DOCKETED	
Docket Number:	19-BSTD-03
Project Title:	2022 Energy Code Pre-Rulemaking
TN #:	237045
Document Title:	Lutron Comments on the 2019 Title 24 Part 6 Building Energy Efficiency Standards Pre-Rulemaking Express Terms
Description:	N/A
Filer:	System
Organization:	Lutron Electronics Co., Inc.
Submitter Role:	Public
Submission Date:	3/9/2021 7:22:41 AM
Docketed Date:	3/9/2021

Lutron Comments on the 2019 Title 24 Part 6 Building Energy Efficiency Standards Pre-Rulemaking Express Terms

Lutron Electronics Co., Inc. Comments on the 2019 Title 24 Part 6 Building Energy Efficiency Standards Pre-Rulemaking Express Terms

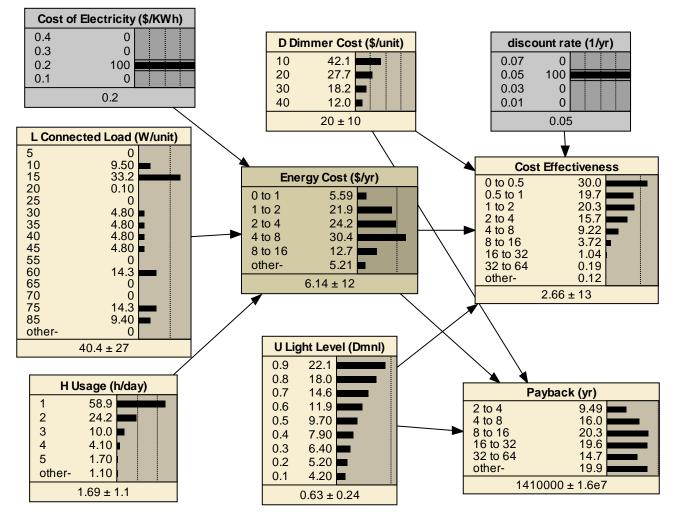
Lutron comments: The draft Title 24 2022 language is a significant backslide in energy efficiency compared with Title 24 2019 requirements. The draft language still has the requirements for the lighting controls but there is an exception which eliminates their use in most instances. Today, luminaires that are or contain JA8 light sources, must use a dimmer or an occupancy sensor or vacancy sensor. The new language and new exception remove these requirements when the circuit lighting power is less than 50 watts, essentially negating the requirement. A permanent energy-saving control should be used as they help maintain and ensure energy savings over the long term. Thus, we urge the commission to not backslide on the lighting level with no restriction to the connected load, most of the applications save energy cost effectively using the CEC Benefit-to-Cost Ratio (See Figure 1). If each room needs to be cost-effective, then it should be limited to no more than 20 watts instead of 50 watts. 20 watts has a 1.02 Benefit-to-Cost ratio which passes the CEC criteria for cost effectiveness (See Figure 2). Lastly, allow for occupancy/vacancy sensors to be an alternative to dimmers in the habitable spaces just like they are today. This will help provide more flexibility in the design and for the users.

Fig. 1 shows that from a building level perspective, using the connected lighting load distribution (W/unit) and the average lighting usage hours (h/day) taken from the <u>CEE Residential Lighting Controls</u> <u>Market Characterization</u> report, dimmers in typical 3 bedroom, 2 bathroom home are cost effective in 50.2% of the cases (i.e. Benefit-to-Cost Ratio greater than 1.0). The cost effectiveness improves if we use 3-hours per day usage (per the <u>Lighting Facts</u> label) instead of 1.69 hours per day, and/or a 3% discount rate instead of 5%.

EXCEPTION 2 to Section 150.0(k)2F: Luminaires connected to a circuit with controlled lighting power of less than 50 watts are not required to have dimming controls. Luminaires controlled by an occupancy or vacancy sensor providing automatic-off functionality.

EXCEPTION 2 to Section 150.0(k)2F: Luminaires connected to a circuit with controlled lighting power of less than 520 watts are not required to have dimming controls.

EXCEPTION 3 to Section 150.0(k)2F: Luminaires controlled by an occupancy or vacancy sensor providing automatic-off functionality.

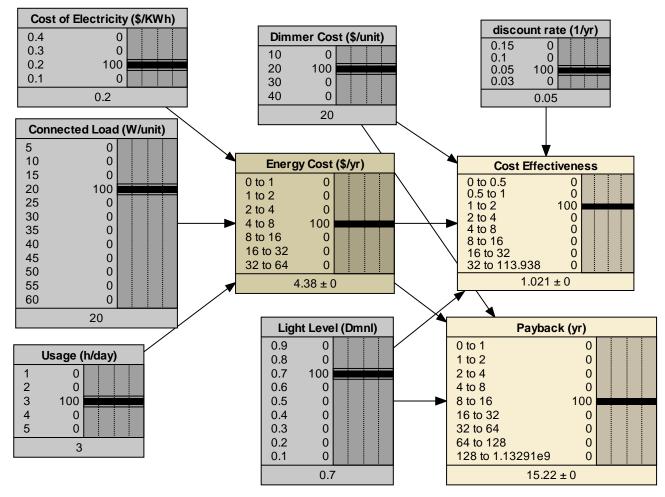
Fig. 2 shows that at a room level, using a 20 watt connected lighting load distribution (W/unit) and the average lighting usage hours of 3 hours per day (h/day) taken from the <u>Lighting Facts</u> label, dimmers are cost effective (i.e. Benefit-to-Cost Ratio greater than 1.0). The cost effectiveness improves if we use a 3% discount rate instead of 5%, and/or higher than 20 watt connected lighting loads.
